Eagle Mountain City  
City Council Staff Report  
August 2<sup>nd</sup> 2016

Project:	<b>Evans Ranch</b>
Applicant:	Nate Shipp/DAI
Request:	Preliminary Plat and Master Site Plan
Type of Action:	Action Item

This Staff Report covers two separate applications for the Evans Ranch Development. The applications are interrelated, as are the issues and items for consideration. This report covers a request to approve a preliminary plat for the townhome and cottage lot portion of the development, and adopt a master site plan for the townhome area of the project.

TOWNHOME & LOT LAYOUT

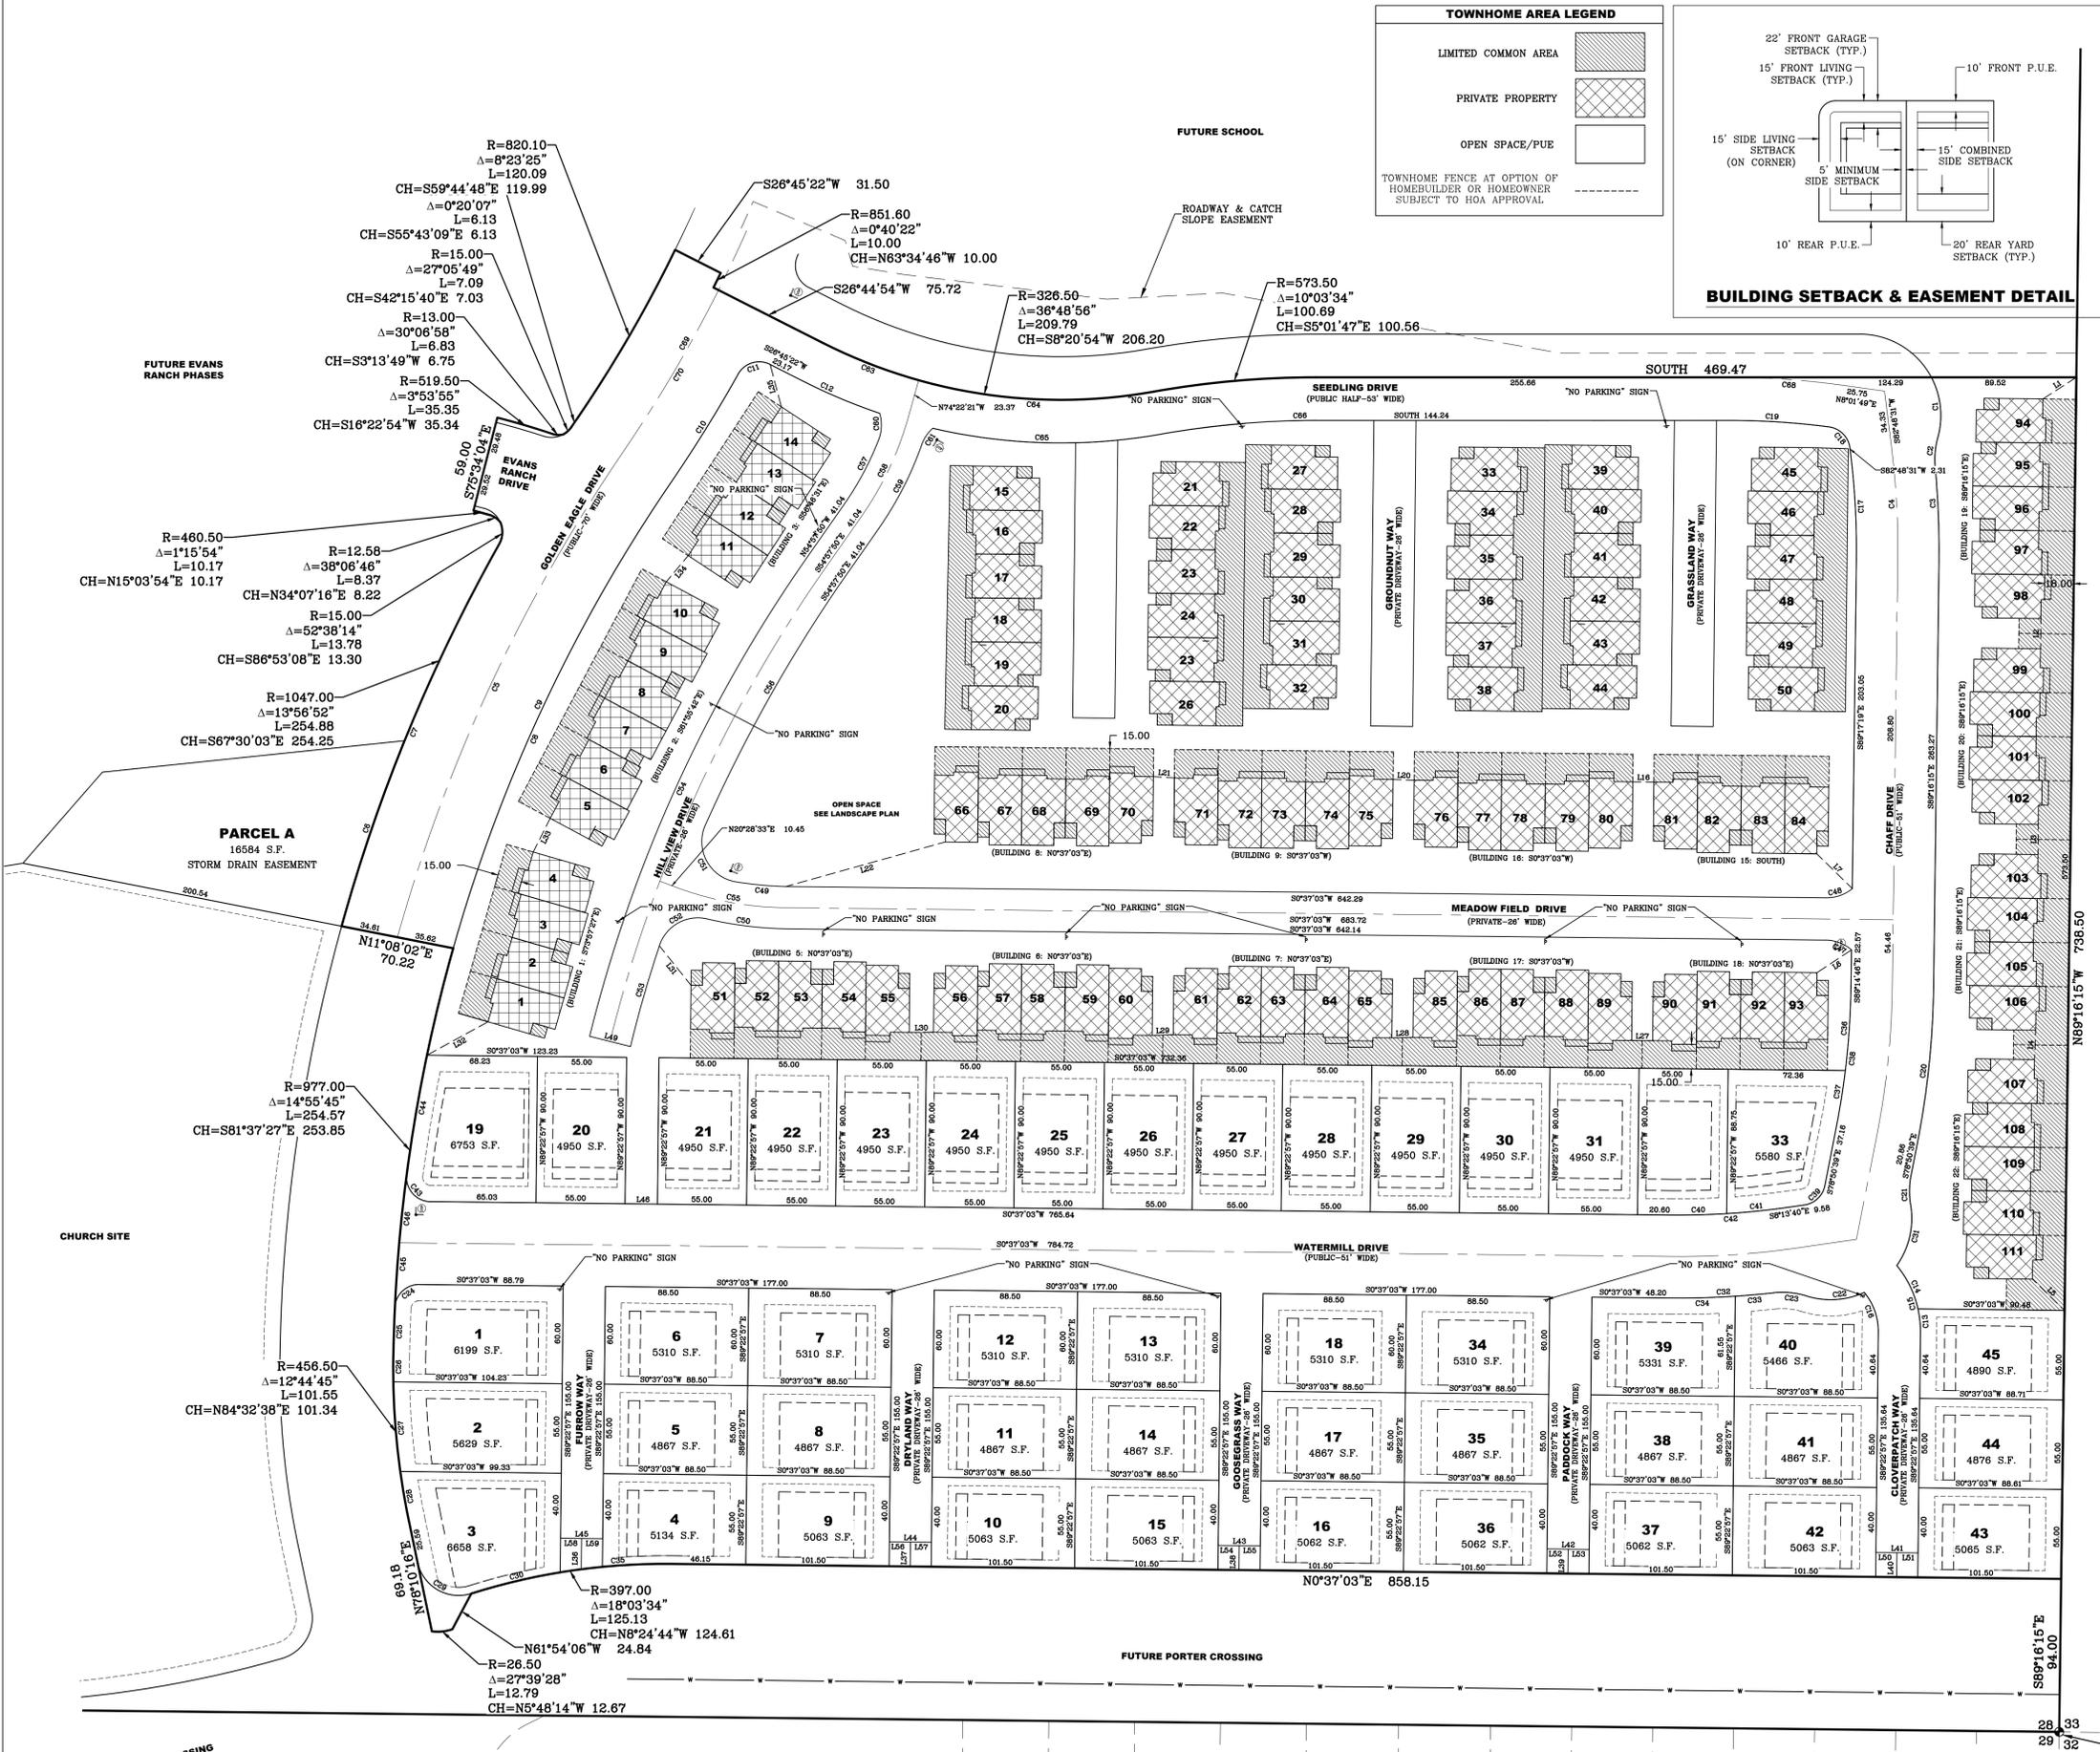
A preliminary plat review includes the layout of lots, and proper street circulation, utility demands, park and recreation sites, etc. The applicant is proposing 112 townhome units and 45 Single Family Cottage lots for a total of 157 Units.

Under the currently approved Evans Ranch Master Development Plan the applicant is allowed up to 149 townhomes and 30 cottage lots for 179 total units. Staff and the Planning Commission support the applicant's proposal to reduce the number of townhomes and increase the number of single family units. The proposed Preliminary Plat is provided below:

**Setbacks:** Tier III setbacks require 20' between multifamily units; the applicant has proposed units which do not meet these setback requirements, however, the City Council may approve setbacks that differ from this standard if they so choose. The council has approved setbacks that do not meet this standard in recent subdivisions.

Setbacks for Cottage Lots were established in the Master Development Agreement and should be shown on the plat.

**Parking:** The Parking requirement for townhome units is 2 Stalls per dwelling unit (not in tandem configuration) and 1 guest parking space per 3 dwelling units. 1 space per unit to be within a fully enclosed garage, the requirements for this development are therefore:

- 224 Stalls
  - 112 of which must be Garage Stalls
- 37 Guest Parking Stalls

The applicant has proposed 224 Garage Parking Stalls, and 40 surface parking stalls. The 40 surface parking stalls shall be posted as Guest Parking only.

**1 53' RIGHT-OF-WAY (LOCAL PUBLIC) - (SEEDLING DRIVE)**

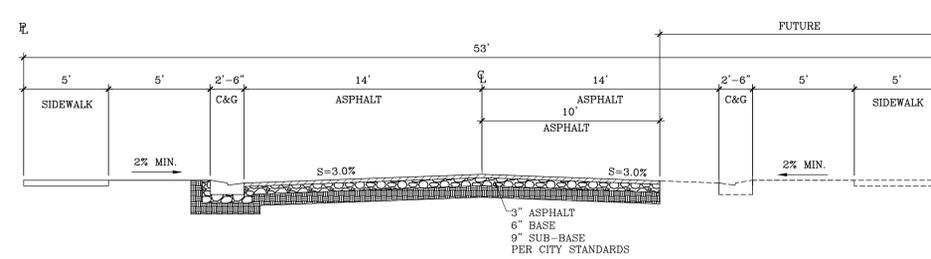
**ROW:** The applicant has indicated they will design public roads to the newly adopted 53’ ROW; however, they were unable to provide plans that showed this standard prior to the Council meeting.

2. Swimming Pool must be bonded for with subdivision improvements phase that contain the 16th building permit
3. No parking on fire hydrant side of 26' private roads
4. Alleys/Driveways must be signed "no parking" at 150' intervals, and the Fire Marshal must approve a signage and striping plan prior to building permits being issued.
5. 6' Estate fence between Cottage Lots and the future extension to Porter's Crossing Parkway should be installed with infrastructure improvements
6. The 40 surface parking stalls shall be signed as guest parking
7. The applicant shall provide street light plans that comply with EMMC
8. A 6' fence be provided between the Tot lot and the Swimming Pool
9. 53' ROW is provided for all public streets

**3 26' PRIVATE STREET - (HILL VIEW DRIVE, MEADOW FIELD DRIVE)**

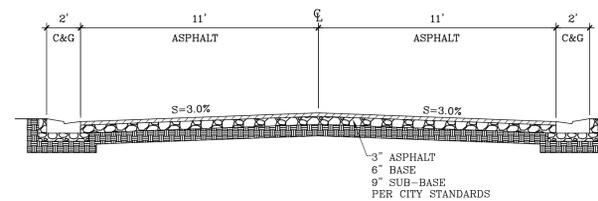
2. Swimming Pool must be bonded for with subdivision improvements
3. No parking on fire hydrant side of 26' private roads
4. Alleys/Driveways must be signed "no parking" at 150' intervals, and the fire marshal must approve a signage and striping plan prior to building permits being issued.
